**NH Department of Environmental Services (NHDES)
Response to Comments and List of Substantive Changes
for
Section 401 Water Quality Certification
WQC # 2017-404I-001**

WQC # 2017-404I-001

Activity Name: Reconstruction of NH Route 12, Walpole-Charlestown X-A000(487),
14747

Owner/ Applicant: New Hampshire Department of Transportation (NHDOT)

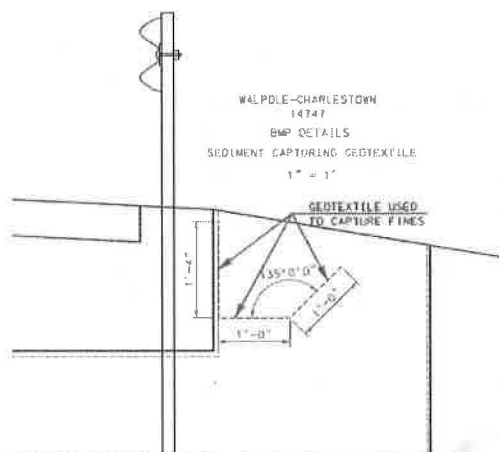
Comment A.1: In my review of the material I noted that the water quality cert requires a review of "hydrologic" impacts. It is my concern that any so called "rip-rap" or bank stabilization work

done by the state will have an impact on the erosion happening downstream. It is a known fact that changing the river bank will affect the banks downstream. I saw no mention that this issue was addressed. I am requesting that the State review the hydrologic impact and review the Corp of Engineers Study as to the impact and issue a report to the Town of Walpole, Village of North Walpole as well as myself.

Response A.1: No changes made to the WQC:

NHDOT ran the U.S. Army Corps of Engineers HEC RAS river hydraulic model to compare pre and post construction characteristics (velocity and flood elevation) of the river. Results indicated the proposed bank between the road and the river is not expected to result in any significant change in river characteristics in the vicinity or downstream of the project.
